OFFICIAL NOTICE AND AGENDA

1. Call to Order
2. Request by Scott Truehl for site plan approval to construct a building addition at The Printing House/Madison Powder Coating, 540 Business Park Circle.
3. Future agenda items.
4. Adjournment.

I have completed a review of the proposed 13,425 square foot building addition for The Printing House/Madison Powder Coating at 540 Business Park Circle. As noted, additional information may be required to be provided or shown on the plans.

540 BUSINESS PARK CIRCLE - STOUTHTON
 GRADING AND EROSION CONTROL AND UTILITY PLAN
 SHEET: C-3
 DATE: APRIL 3, 2020

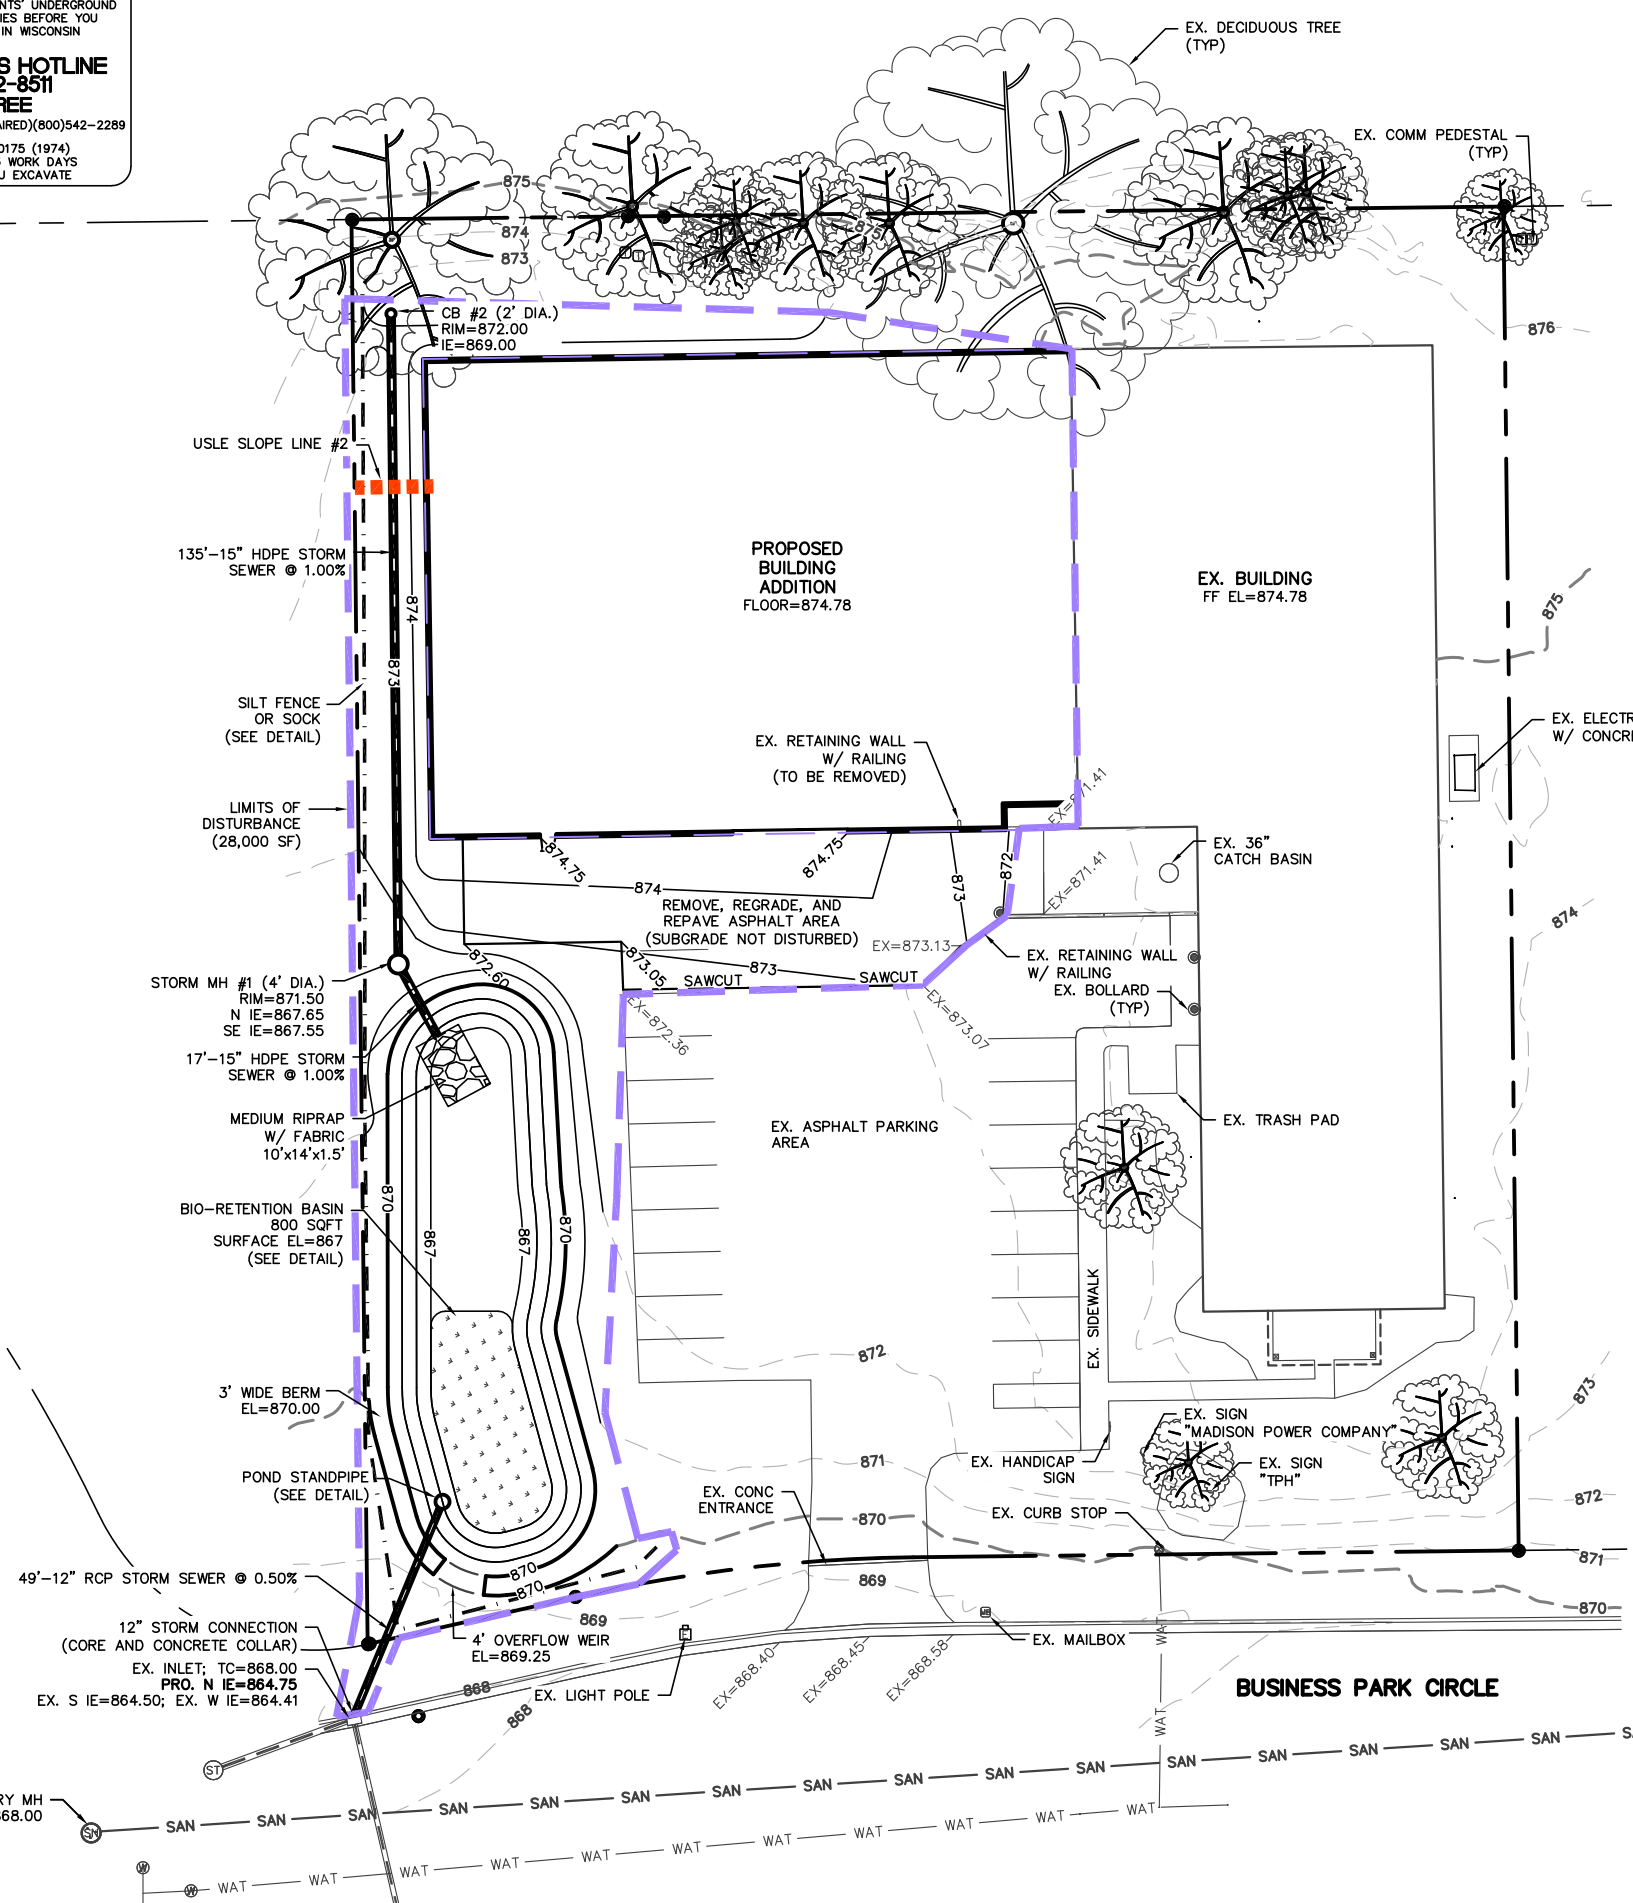
18. A stormwater management and erosion control plans, application and fees are required for this project. Dane County Land & Water Resources, the City’s consultant, will review the plan and perform inspections. **The plan, application and fees shall be submitted electronically to the Department of Planning & Development office.**

- c. Exterior signs. **No signage proposed.**
 - d. Exterior Lighting. **One building wall pack proposed.**
 - e. Clearing, grading, and drainage plan showing proposed clearing limits, existing and proposed contours at two foot intervals. **A grading plan is provided.**

540 BUSINESS PARK CIRCLE - STOUGHTON
 LANDSCAPE PLAN
 SHEET: C-4
 DATE: APRIL 3, 2020

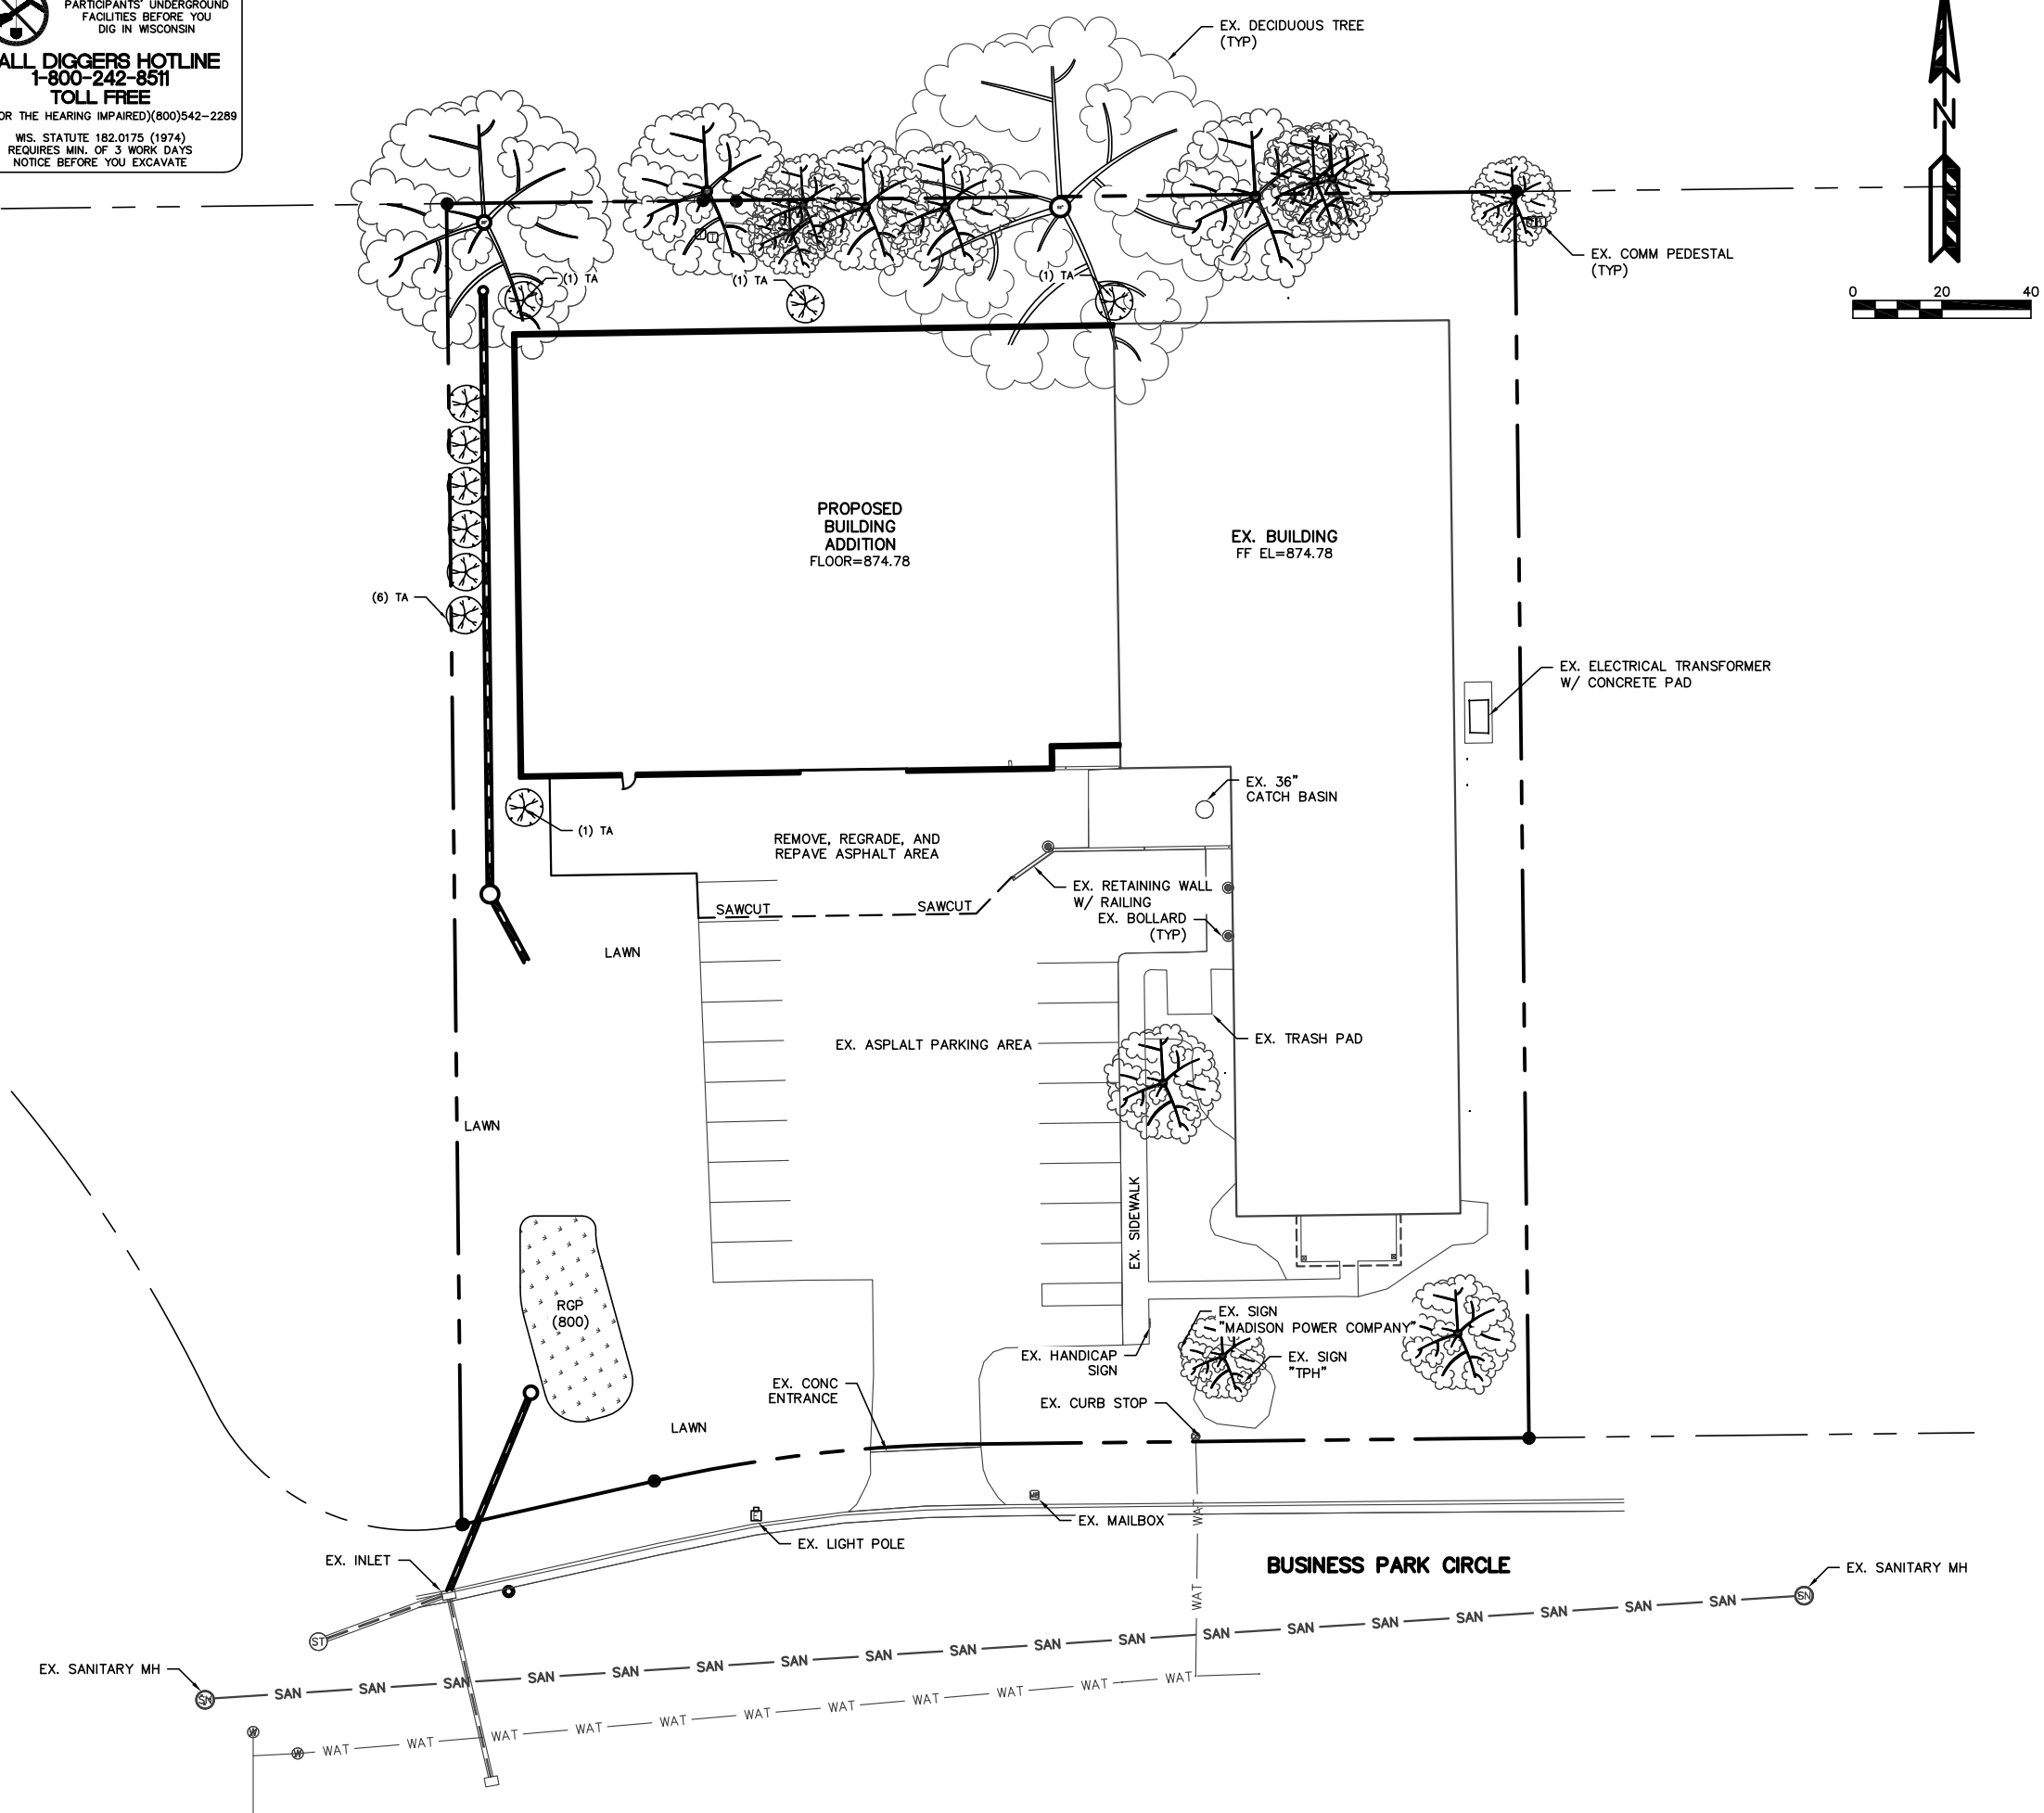
- Building foundations: 40 points of landscaping are required per 100 feet of foundation perimeter. 372 feet of foundation requires 149 points of landscaping which is required to be planted within 10 feet of the building foundations. Climax and tall trees cannot be used to meet this requirement. **The plan meets this requirement though the calculation uses 4 sides of the building addition. The attached side is not counted since there is no way to install foundation landscaping there. Landscaping is not recommended to be placed within any recorded easement.**
